# 4 Case #SUB2007-00040

## MCGOWIN INTERSTATE SUBDIVISION, RESUBDIVISION OF LOT 2

APPLICATION NUMBER 4 DATE March 15, 2007

## DETAIL SITE PLAN

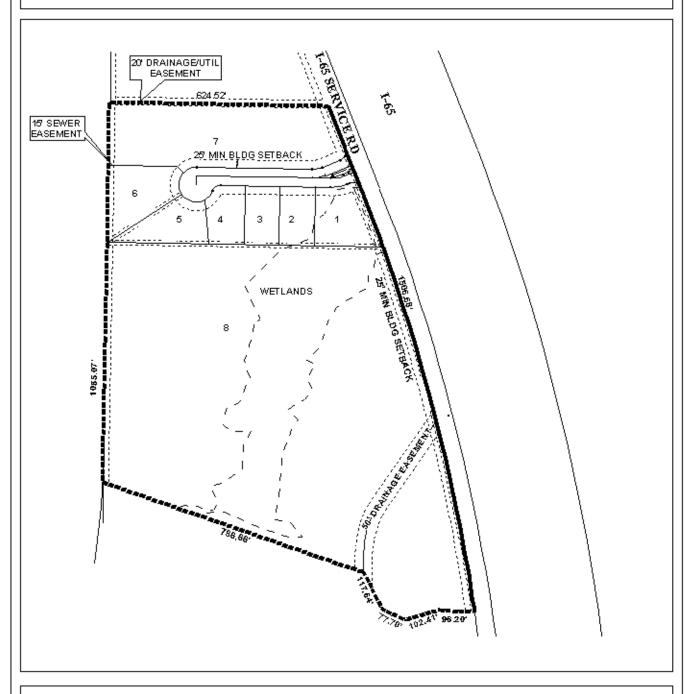
The site involves the creation of a new street, which must be constructed to City Engineering standards. The applicant is proposing to develop the site in phases, saving the construction of the proposed street for later phases. Access management is a concern for the subdivision, and it is recommended that Lots 2-6 be limited to one curb-cut each onto Spunner Court. Lot 7 has frontage onto Spunner Court and the service road, however, as Spunner Court may not be constructed until later phases, Lot 7 should be allowed one curb-cut onto West I-65 Service Road South with the condition that the curb-cut be closed when Spunner Court is completed, at which time Lot 7 should be allowed three curb-cuts onto Spunner Court. Similar to Lot 7, Lot 1 should be allowed one curb-cut onto West I-65 Service Road South with the condition that the curb-cut be closed when Spunner Court is completed, at which time Lot 1 should be allowed one curb-cut onto Spunner Court. Proposed Lot 8 has approximately 1000 feet of frontage onto West I-65 Service Road South, and should be a limited to three curb-cuts onto the service road. The size, design and location of all curb-cuts must be approved by Traffic Engineering and conform to AASHTO standards.

way will require a right of way permit.); 2) placement of a note on the plat stating that Lots 1 and 7 are limited to one-curb each onto West I-65 Service Road South until such time that Spunner Court is completed, then Lot 1 is limited to one curb-cut onto Spunner Court and Lot 7 is limited to three curb-cuts onto Spunner Court, with the curb-cuts onto the service road closed, that Lots 2-6 be limited to one curb-cut onto Spunner Court, and that Lot 8 is limited to three curb-cuts onto West I-65 Service Road South, with the size, design and location of all curb-cuts to be approved by ALDOT and Traffic Engineering and conform to AASHTO standards; 3) labeling of each lot with its size in square feet, or provision of a table on the plat with the same information; 4) construction of Spunner Court to City of Mobile standards, when it is constructed; and 5) full compliance with all other municipal codes and ordinances.
